Disney Sweater Ltd.

Barpa, Rupshi, Rupgonj, Narayangonj
(23.747071N, 90.536042E)

22nd February, 2017

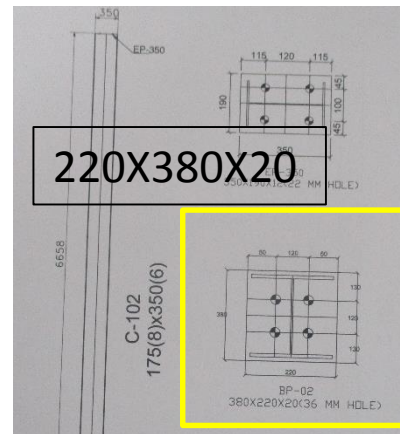
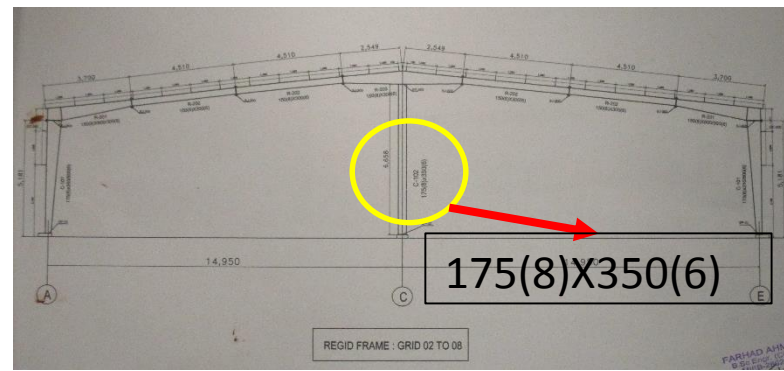
Bracing layout, steel columns and base plate sizes doesn't match with structural drawings.

Drawings shows columns are 175(8)X350(6) mm but on site column of 175(8)X300(6) mm was observed. Base plate was observed 220X330X20 instead of 220X380X20. Building Engineer is required to check the as built condition and prepare as built drawings. Also required to check the structural adequacy for the reduced size of section.

Bracing layout

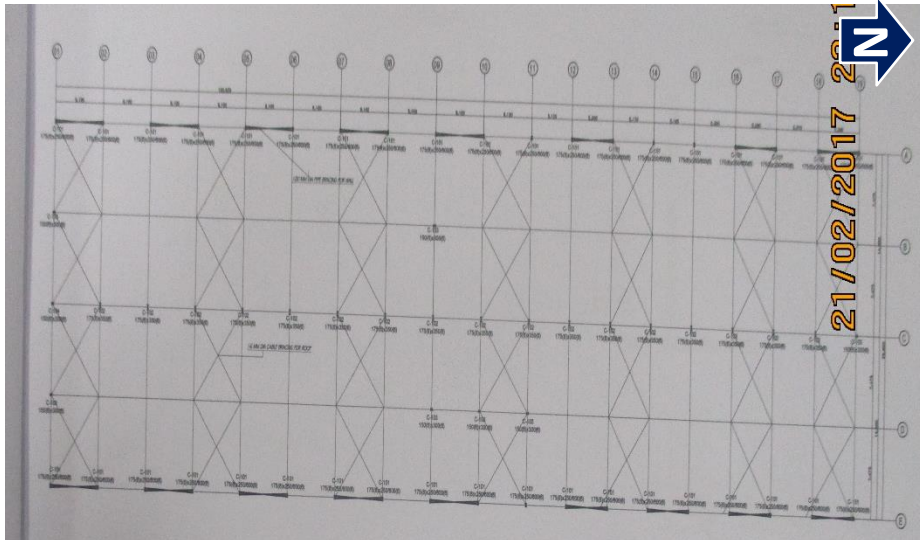
Missing bracing

This frame
suppose to
be gable
frame.

Roof bracings were not installed as per drawings. It may effect the stability of the shed against lateral loading. Building engineer is required to check the lateral stability of the shed against lateral loading.

Wall bracing layout

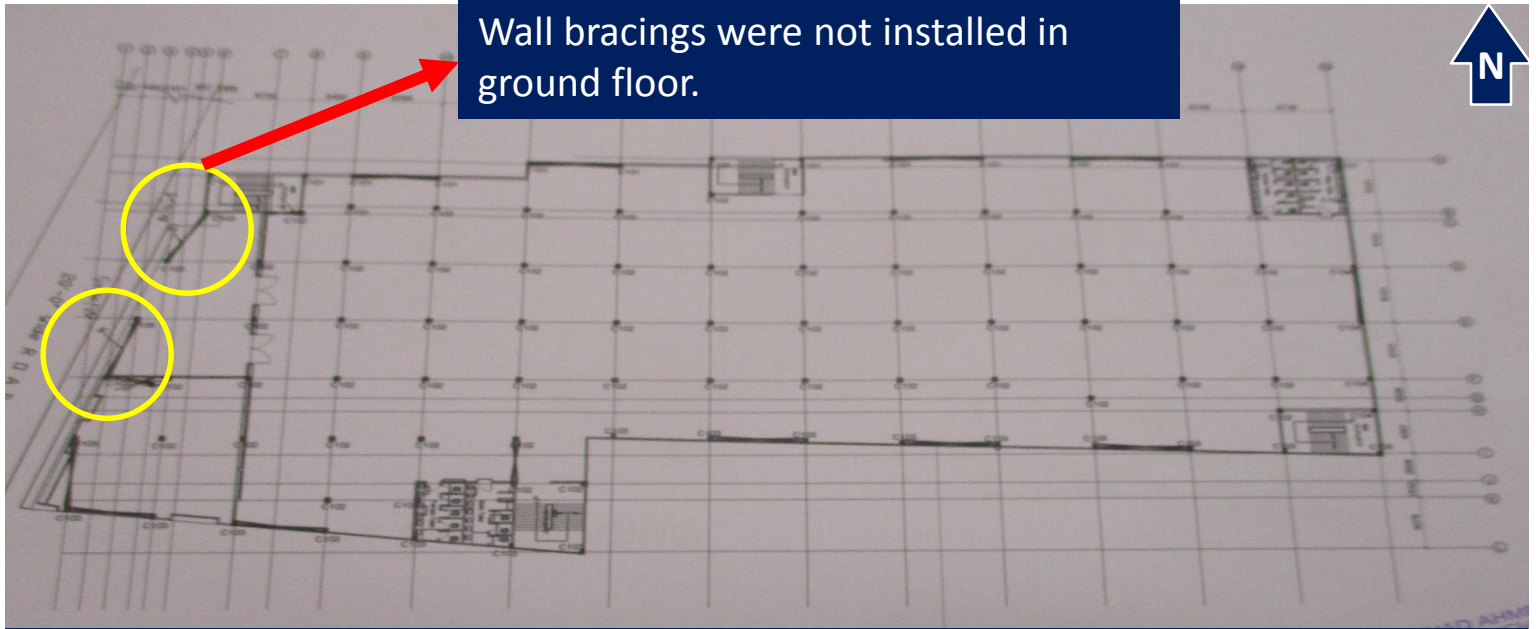
Wall bracings were found missing

Wall bracings were not installed in ground floor.

Wall bracing missing area in ground floor

Wall bracings were missing as per drawings. Building engineer is required to check the drawings and install bracing where required.

Column layout plan

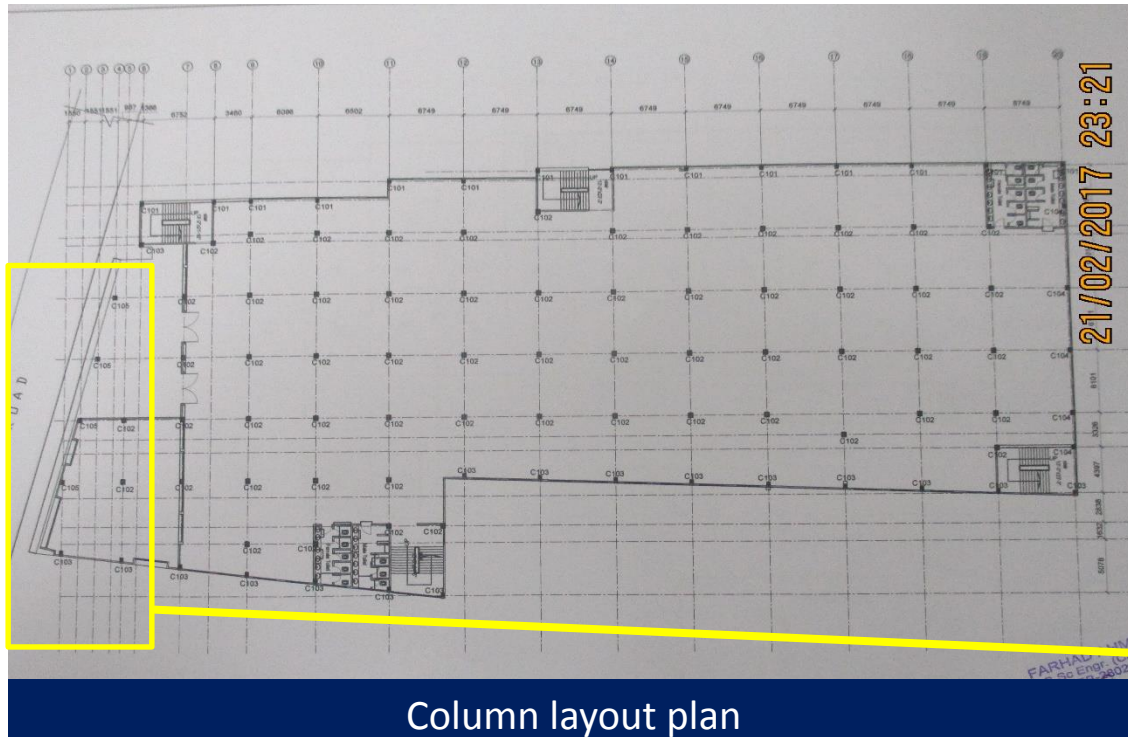
Column layout and size doesn't match with drawings.

Column layout of this portion doesn't match with drawings.

Building engineer is required to check the site condition and update the as built drawings.

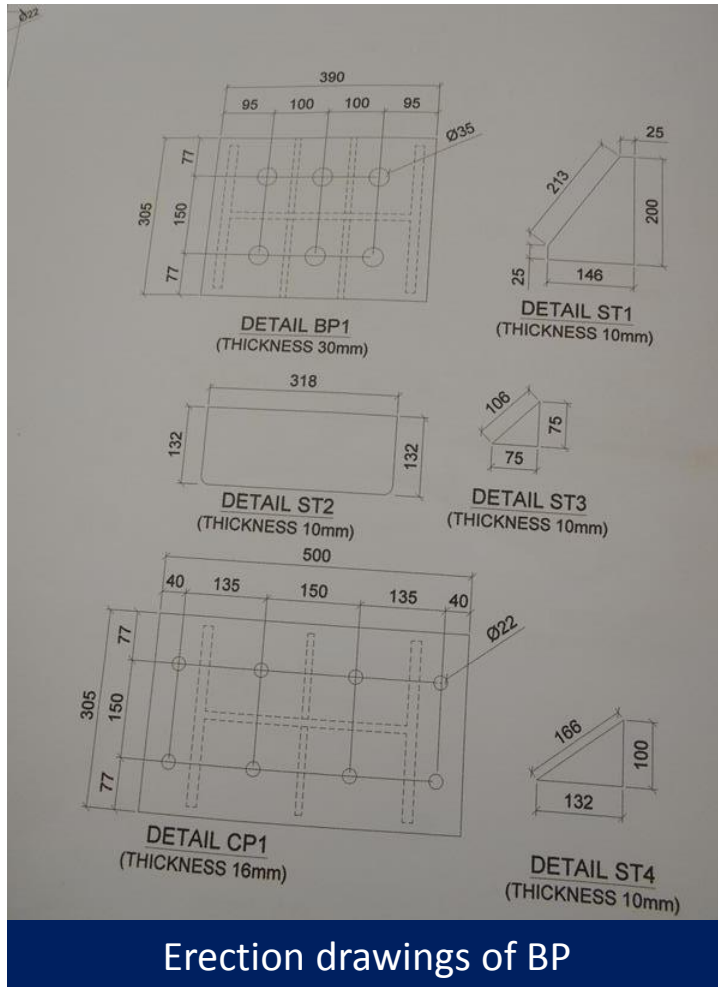
Several columns were found short of 10mm as per drawing
